Expanded Community Advisory Panel (XCAP)

THIS PACKET INCLUDES:

A compilation of emails (public comments, etc) submitted to the XCAP email box, XCAP@CityofPaloAlto.org, between **May 7 and May 20, 2020 at 12:00 pm (noon)**.

Figure 3-4. Relationship between radius and cycling speed [9]

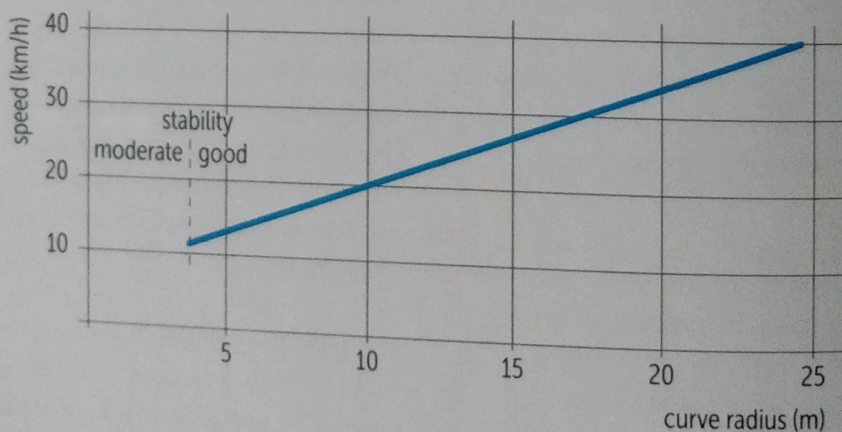
* The plot on the first page shows the turn radius of a bike as a function of speed. At the bottom of the tunnel, bikes will have picked up quite some speed (easily 30 km/h (20 mph)), so any curve would need to be bigger than about 15 m (50 ft). The corner of the Kellogg Tunnel with the Embarcadero bike path has a very sharp corners which would be a bad idea.

Figure 3-5. Bandwidths for gradients [8]

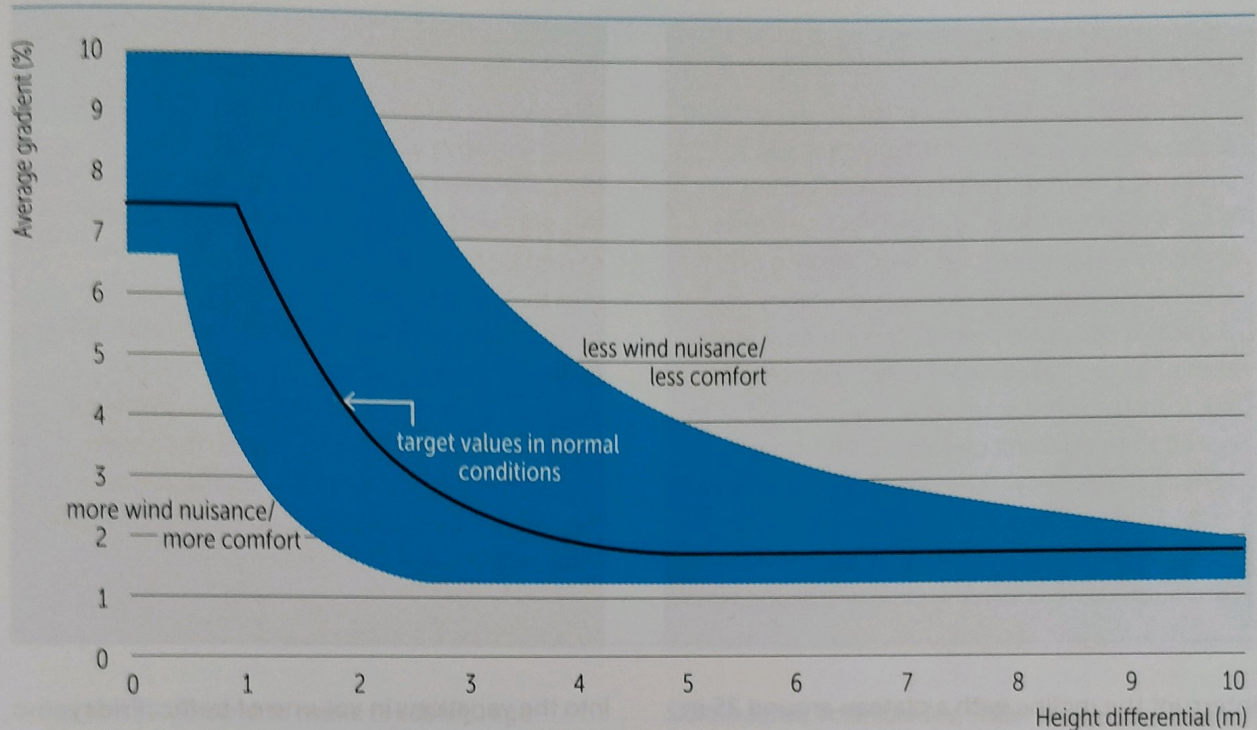
* The second page shows comfortable gradients. I could not guess the gradients from the renderings, but just something to keep in mind.

V51 Cycle underpass

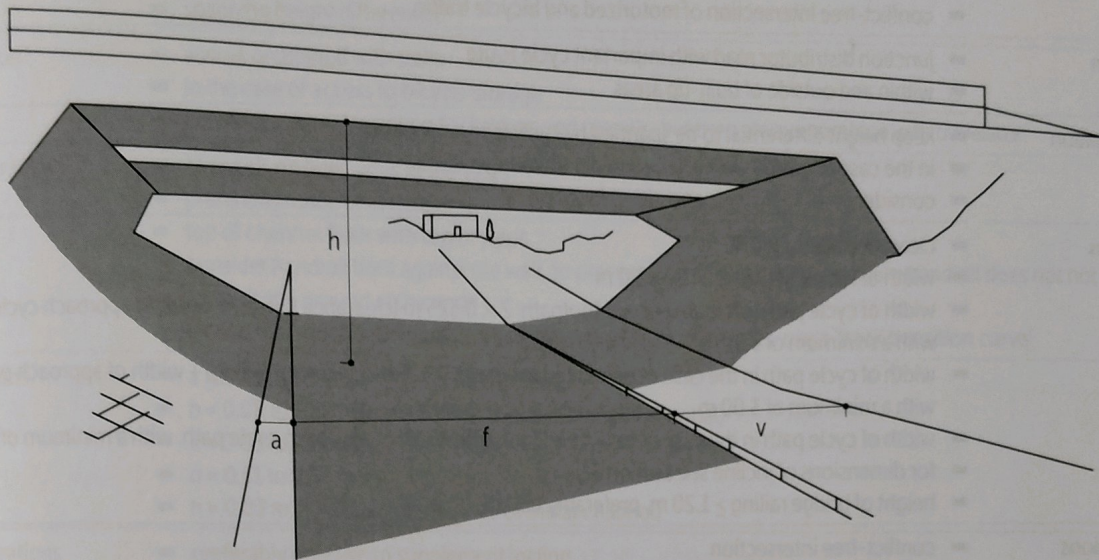
* Last two pages show typical design advice for bike tunnels. One important piece of advice is "no (blind) corners". Sharp corners are difficult to navigate for older riders and people with cargo bikes/trailers, they are dangerous because of poor visibility and because bikes will have gained a lot of speed at the bottom of the downward slope.
